HDC

ADMINISTRATIVE APPROVALS

March 04, 2020

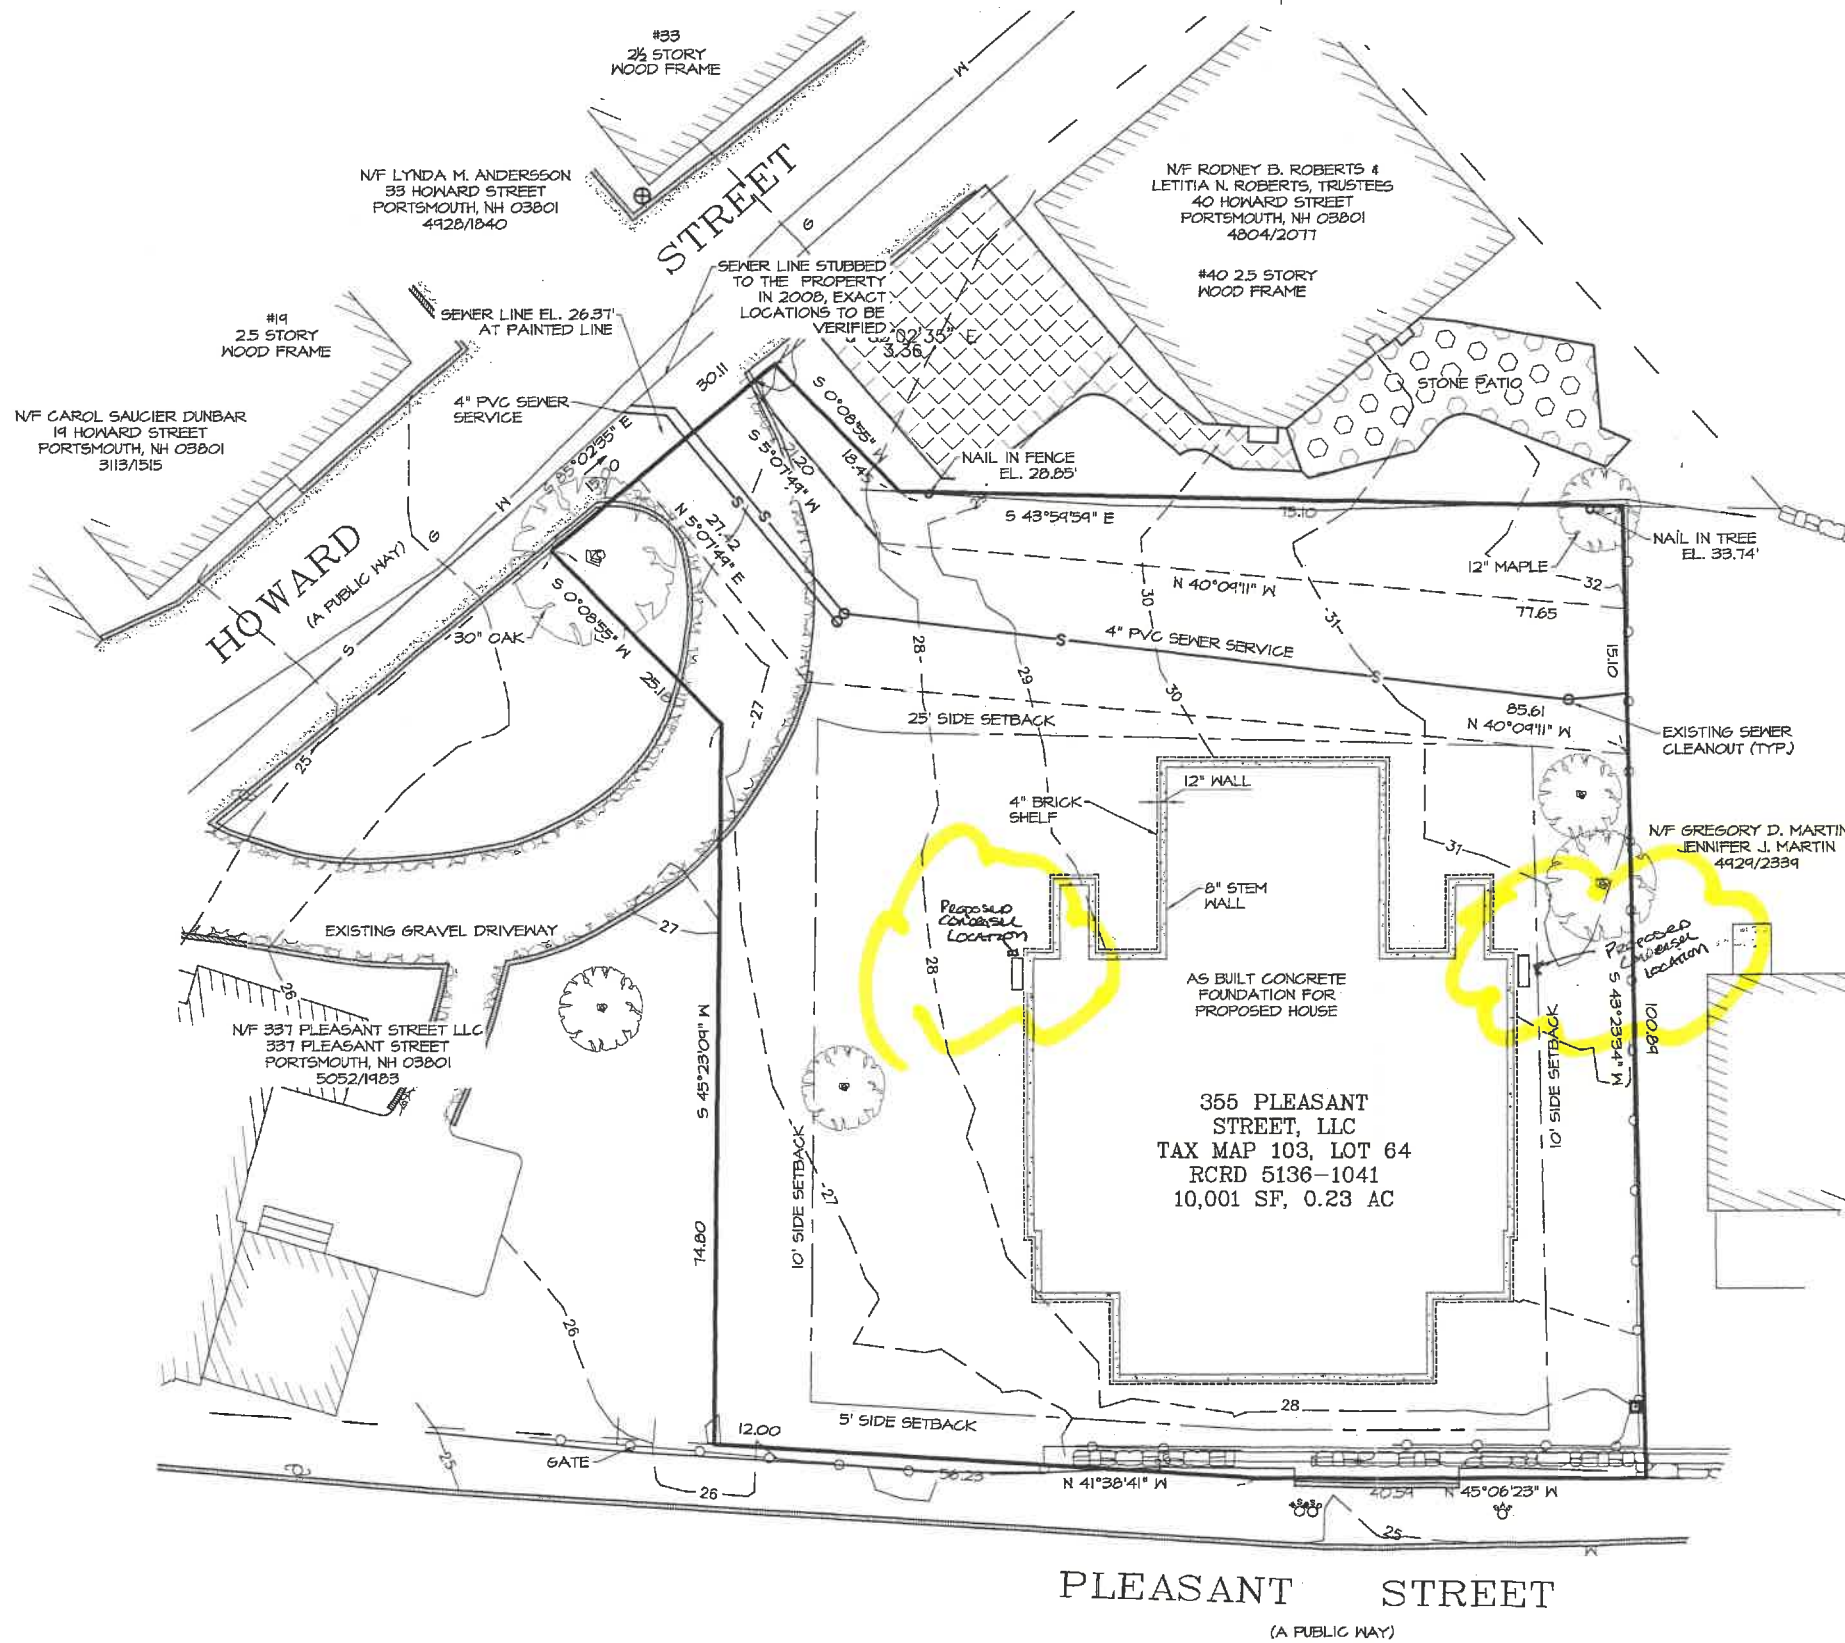
Background: The applicant is seeking approval for the installation of (2) ground-mounted exterior condensers on either side of the structure.

Staff Comment: Recommended Approval

Exhibit 10

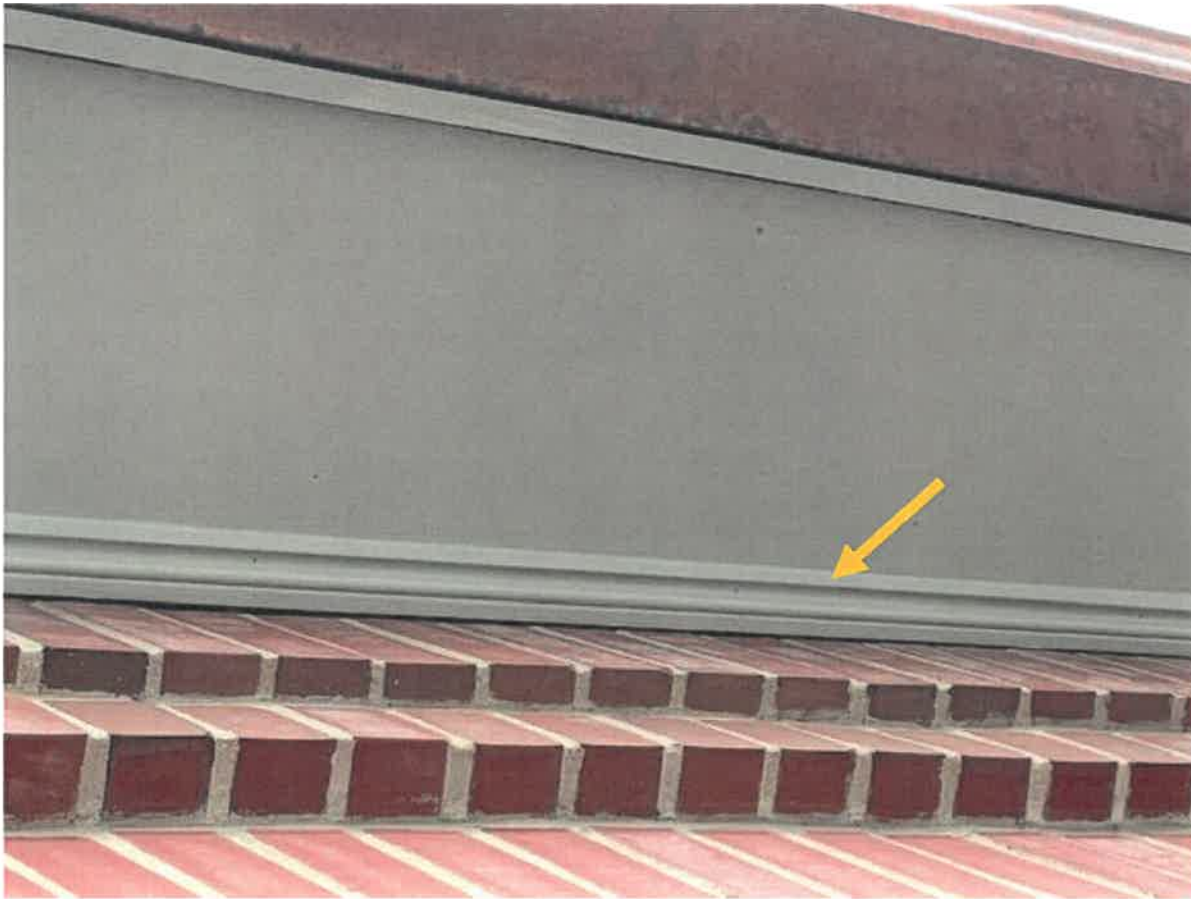
Crown" detail added.

The crown was added to give a clean finished appearance at the transition of the painted soffit and brick face.
